APPEAL SUMMARY

Appeal ID: 23794	**Project Address:** 900 SW Washington St
Hearing Date: 6/10/20	**Appellant Name:** Jesse Emory
Case No.: B-005	**Appellant Phone:** 503-548-2346
Appeal Type: Building	**Plans Examiner/Inspector:** Katherine Aulwes
Project Type: commercial	**Stories:** 35 **Occupancy:** A, R-1, R-2, B, S, S-2, M **Construction Type:** I-A
Building/Business Name: Block 216	**Fire Sprinklers:** Yes - Throughout
Appeal Involves: Erection of a new structure	**LUR or Permit Application No.:** 19-130673-MG
Plan Submitted Option: pdf [File 1] [File 2]	**Proposed use:** Mixed use retail, office, hotel,

Appeal item 1

36 LIFE SAFETY PLAN - LEVEL P4

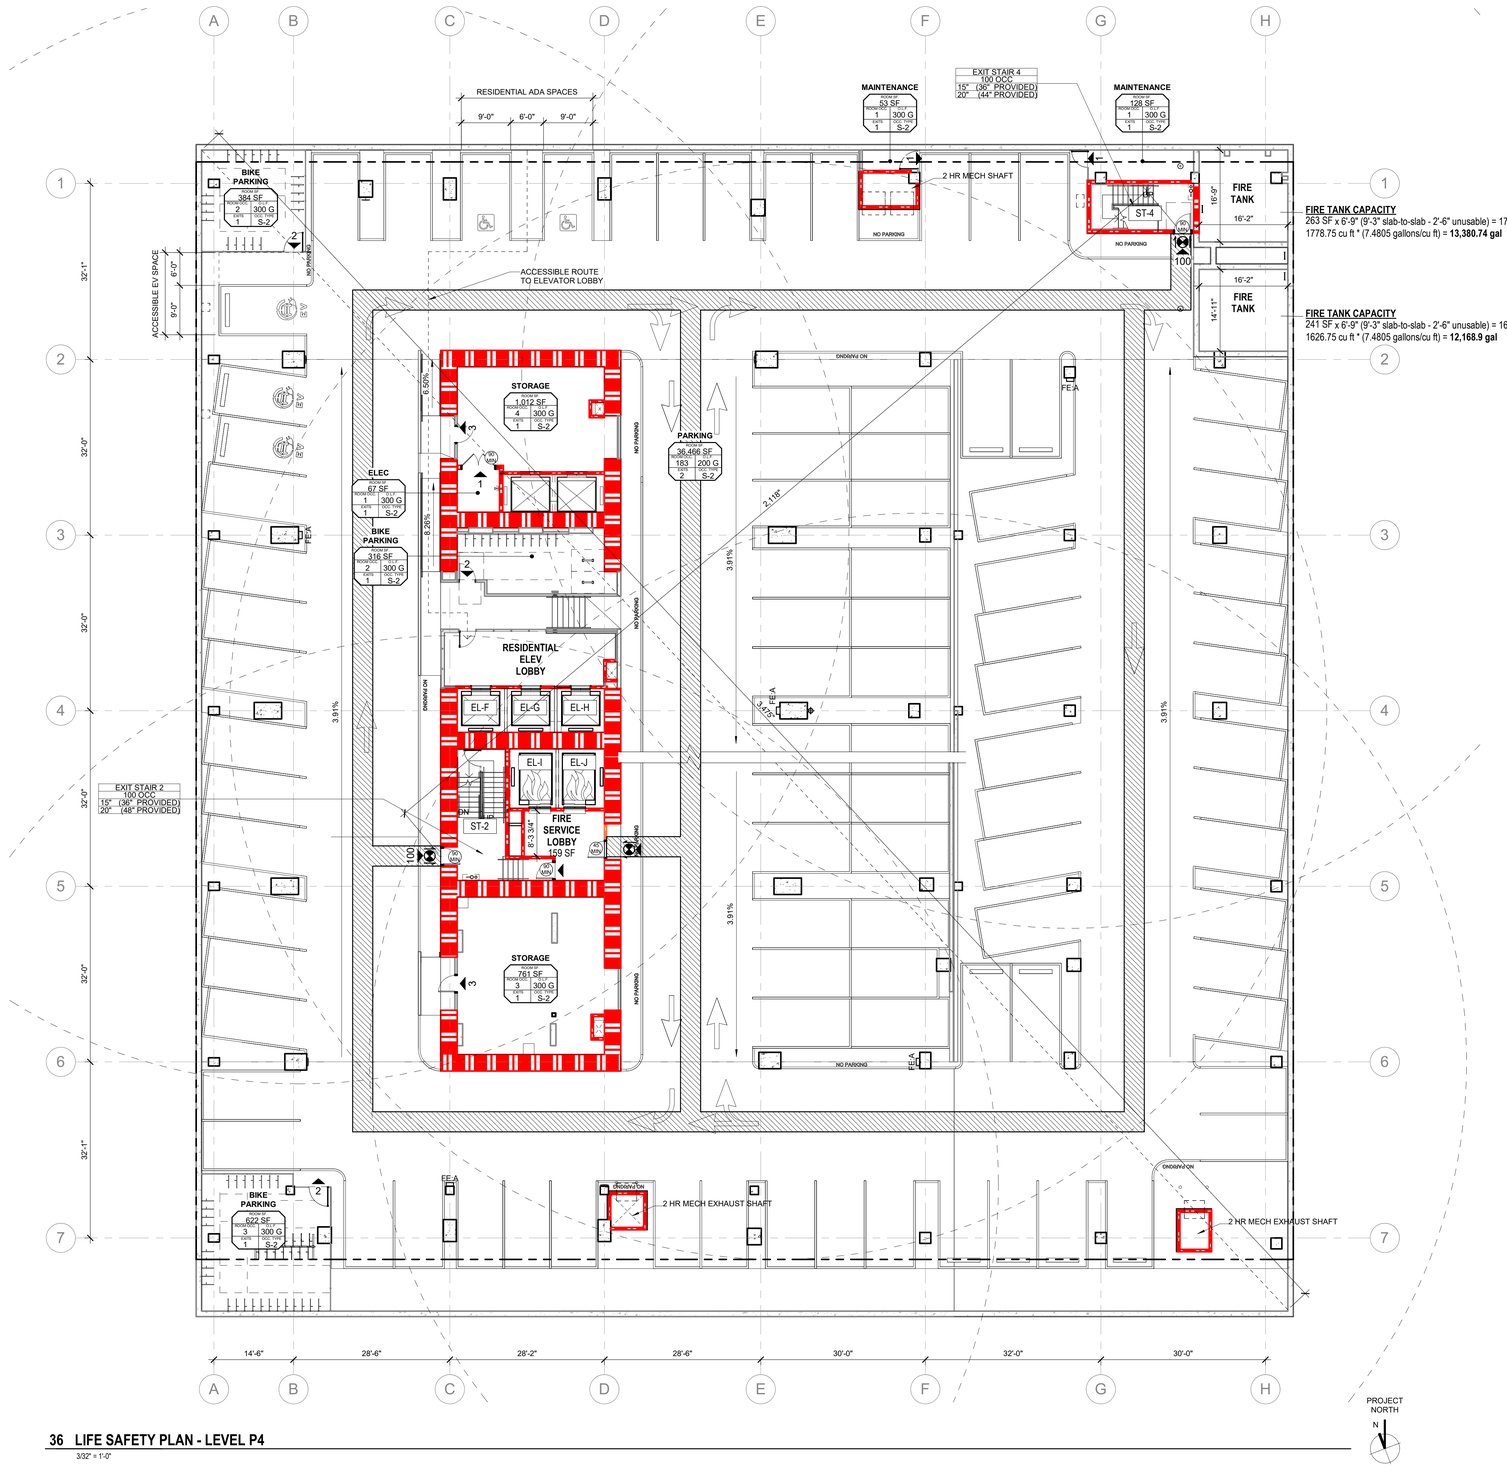
FIRE TANK CAPACITY
263 SF x 6'-9" (9'-3" slab-to-slab - 2'-6" unusable) = 1778.75 cu ft.
1778.75 cu ft * (7.4805 gallons/cu ft) = **13,380.74 gal**

FIRE TANK CAPACITY
241 SF x 6'-9" (9'-3" slab-to-slab - 2'-6" unusable) = 1626.75 cu ft.
1626.75 cu ft * (7.4805 gallons/cu ft) = **12,168.9 gal**

Note: Appeal is not granting the tank capacity shown on the provided section drawing. The capacity of the secondary on-site water supply will be reviewed under the building permit submittal.
Appellant may contact Nate Takara at (503-823-3724) for more information.

36 LIFE SAFETY PLAN - LEVEL 02

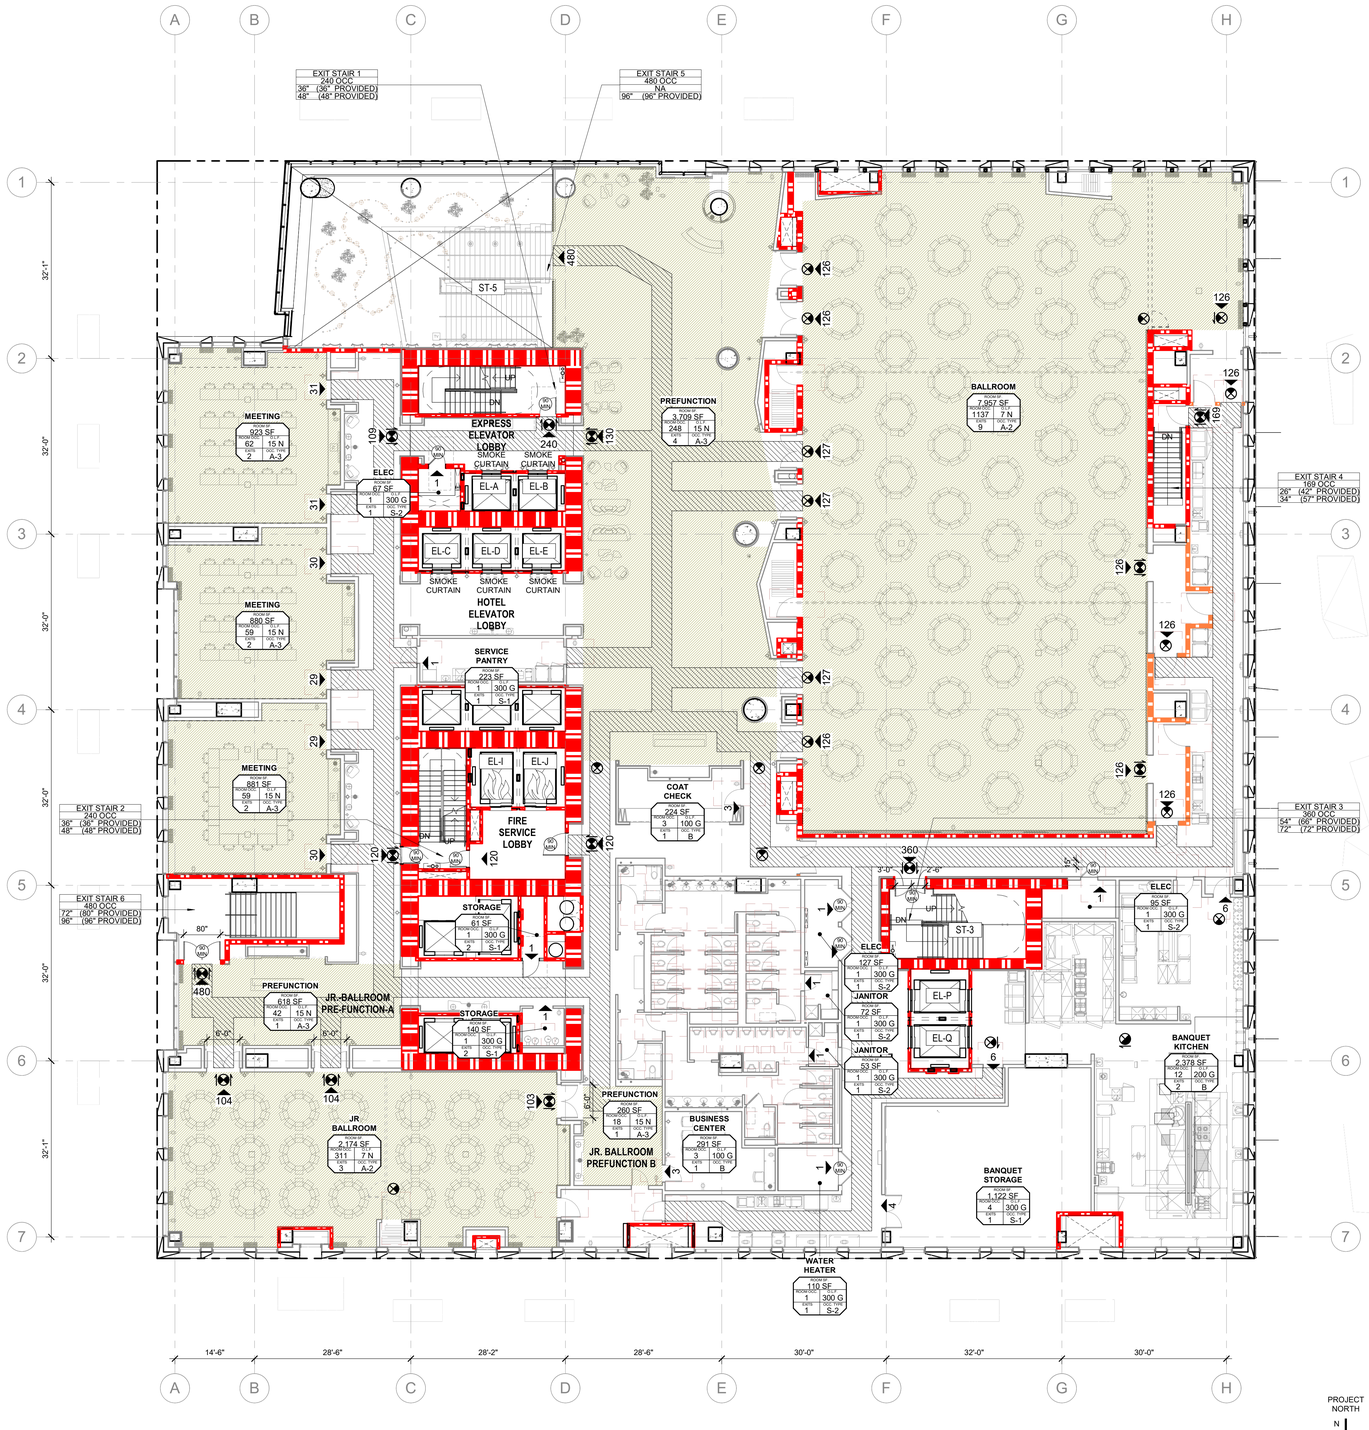
The proposed design is to consolidate and uniformly provide for emergency two-way communication at the protected Fire Service Lobbies, which will also be designated an Area of Refuge. This design approach is to be taken at all occupied floors, P05-35, with the exception of floors 01 and 02. Floor 01 is the level of exit discharge and does not require two-way communication at the elevator landings, and Floor 02 has a very high occupant load which makes the use of Areas of Refuge impractical. Instead, two-way communication will be provided at each elevator landing per bank of elevators on Level 02.

Use of Fire Service Access Elevator Lobbies as areas of refuge and for emergency communication: Granted provided wheelchair clear space is shown on plans to illustrate the minimum required size of the fire service access elevator lobby is not reduced. Will be verified at time of plan review.
Appellant may contact John Butler (503 823-7339) or e-mail at John.Butler@portlandoregon.gov with questions.

ENLARGED CORE PLANS - SOUTH

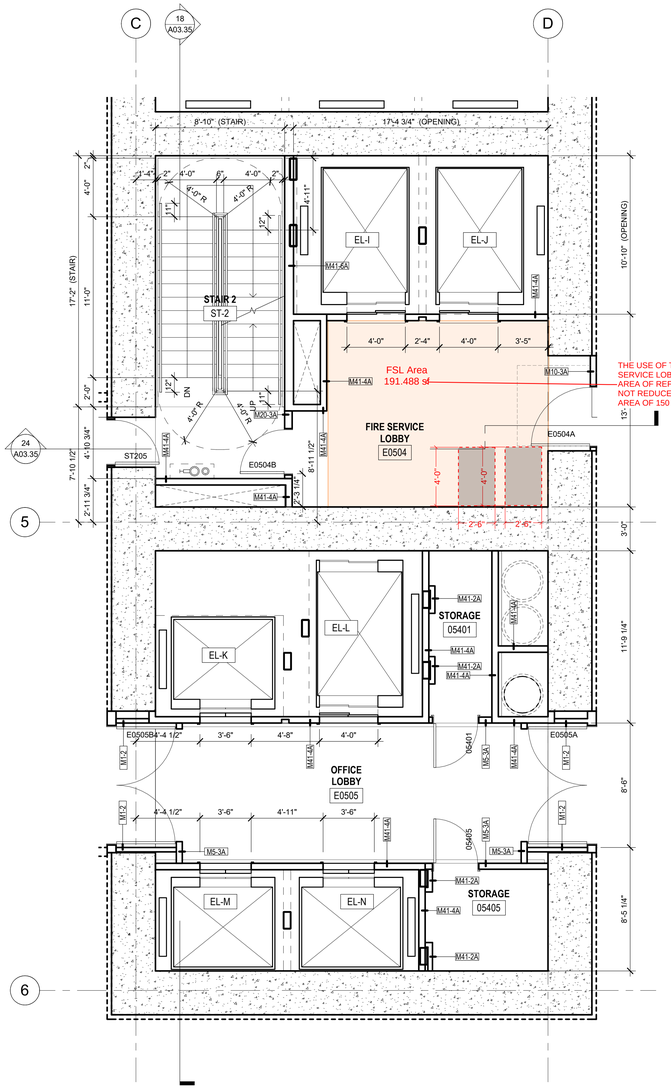
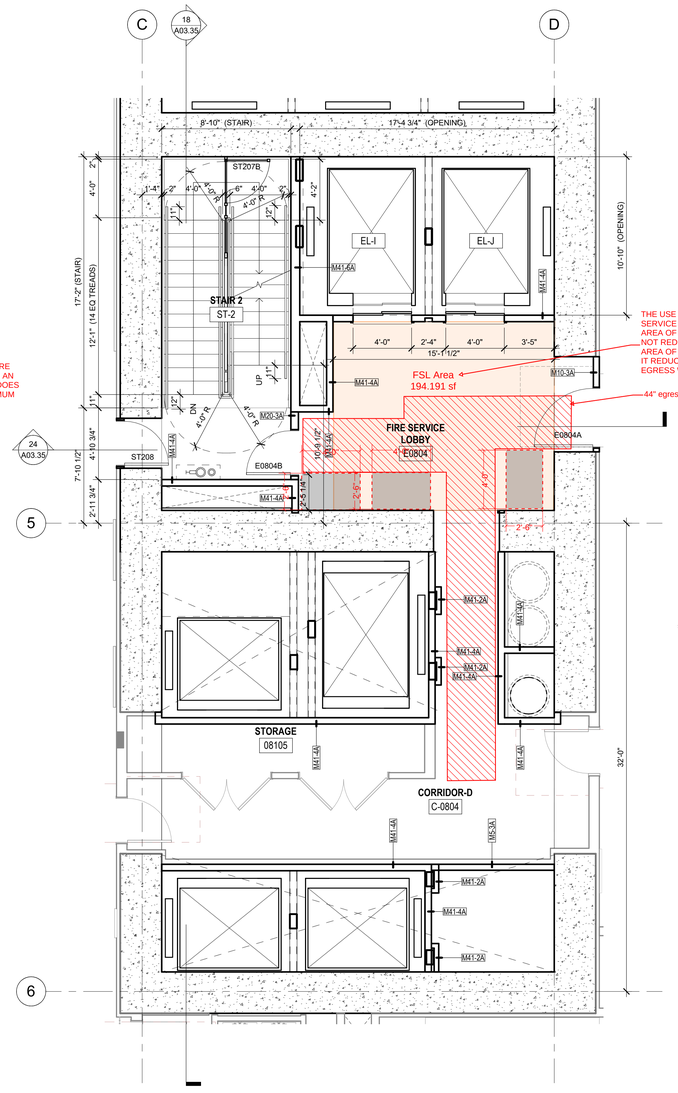
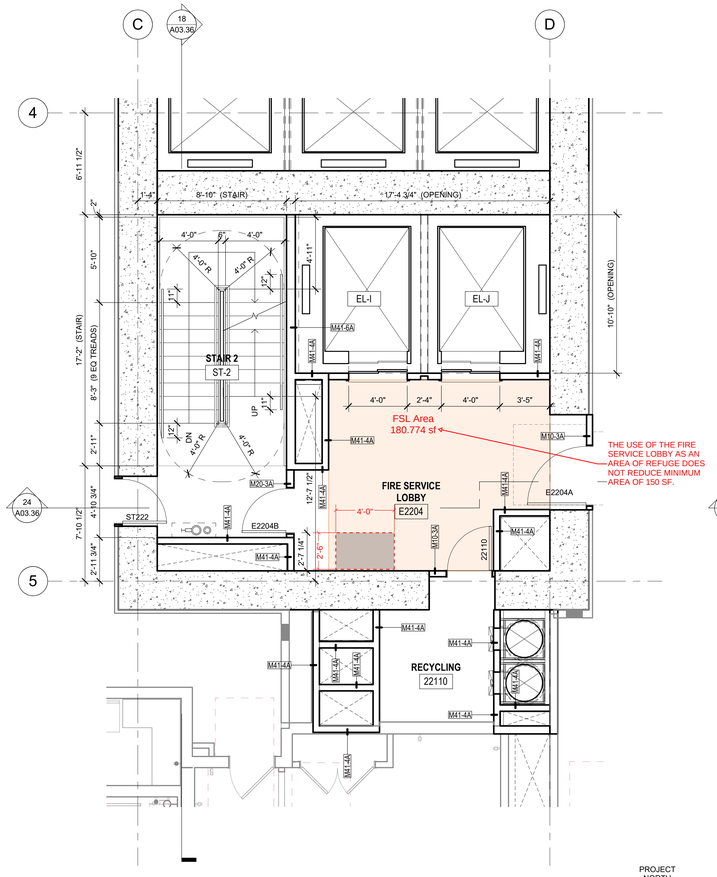
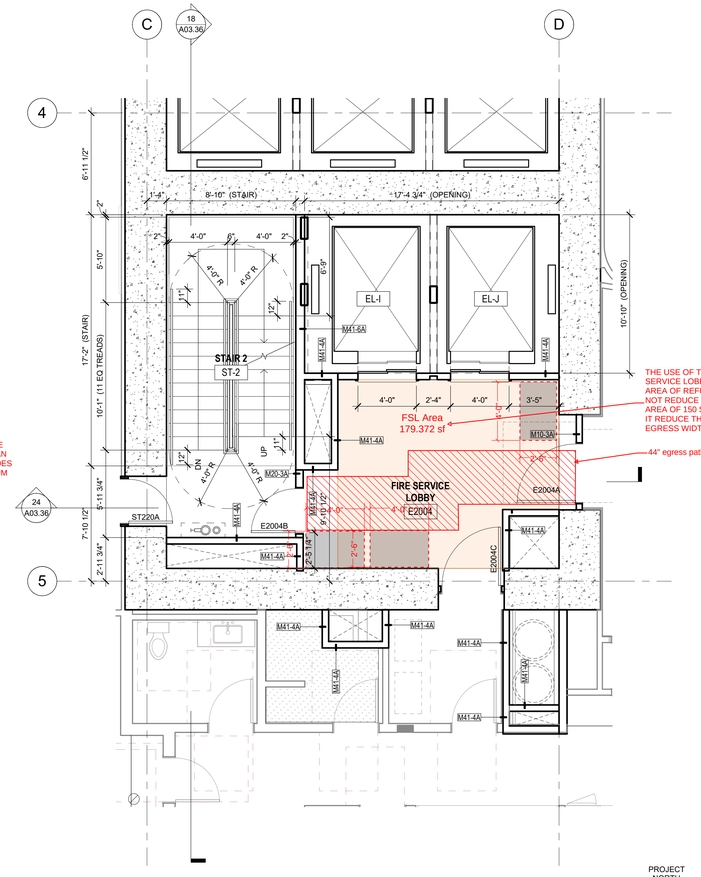
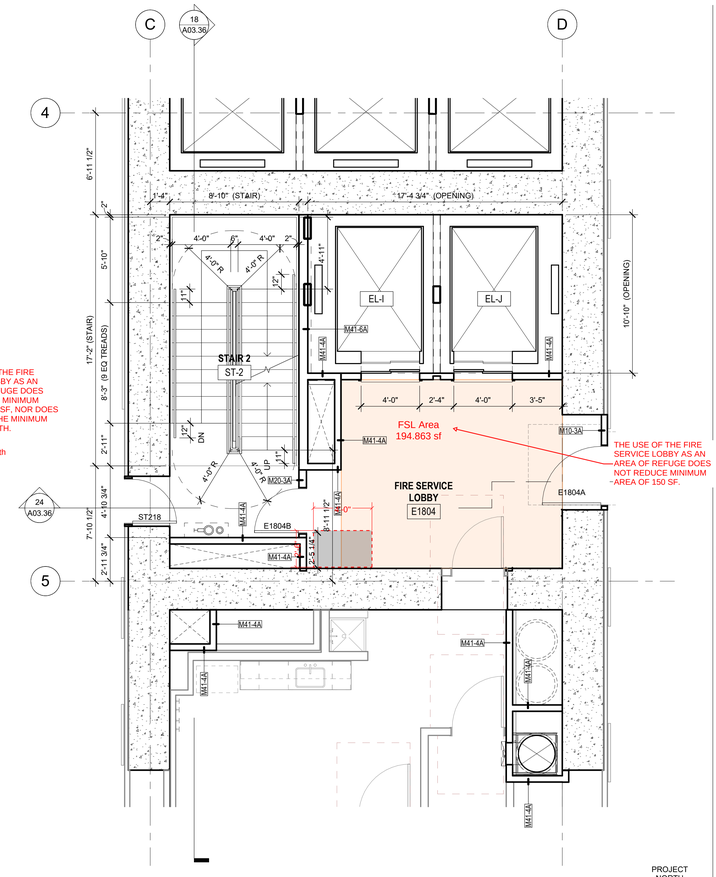
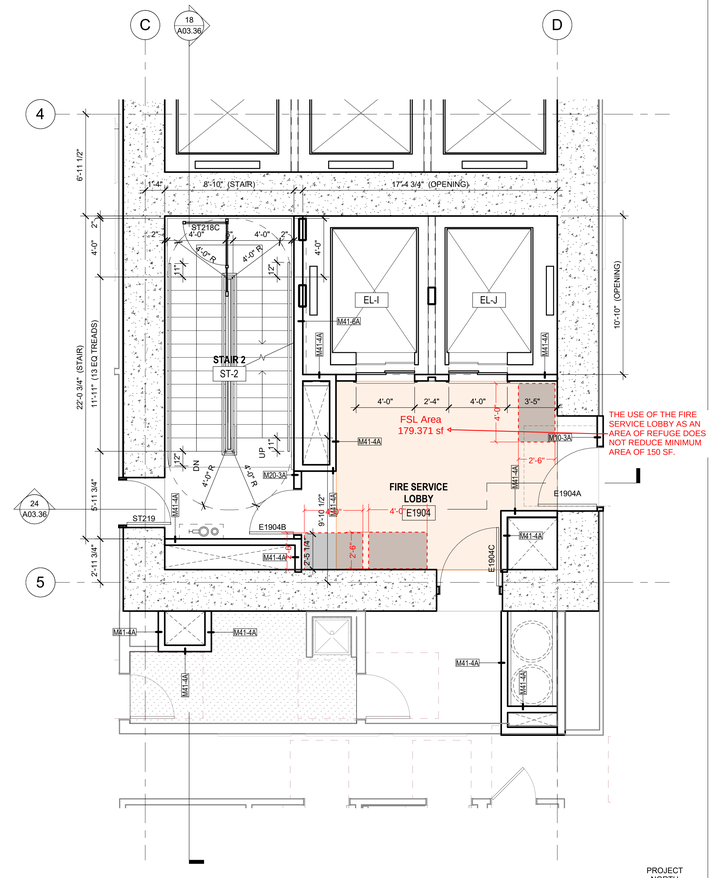
To demonstrate compliance with the requirements of 1009.6.3, the attached core plans note the Occupancy of the floor being served and show the number of 30x48 wheelchair spaces per Area of Refuge. Where the Fire Service Lobby is also being used as a means of egress, the minimum egress width is shown to indicate that the wheelchair spaces do not reduce the means of egress minimum width or required capacity.
Because an Area of Refuge with two-way communication has been provided on each floor, we are meeting the requirements of 1009.8 Exception 1 ; that is, "Two-way communication systems are not required at the landing serving each elevator or bank of elevators where the two-way communication system is provided within areas of refuge in accordance with Section 1009.6.5."

The attached core plans also indicate that the minimum 150 sf area of the Fire Service Lobbies are maintained even with the wheelchair spaces in the Fire Service Lobby. Each 30x48 wheelchair space represents 10 square feet, and where the wheelchair spaces are within the designated area of the Fire Service Lobby and the 10 sf (or a portion thereof) is deducted from the Fire Service Lobby area, the remaining area usable by the Fire Service Lobby still exceeds the 150 sf minimum. The dual designation of "Area of Refuge" and "Fire Service Lobby" to these elevator lobbies does not compromise their functions as a Fire Service, and Area of Refuge, or, at some floors, a component in the path of egress.
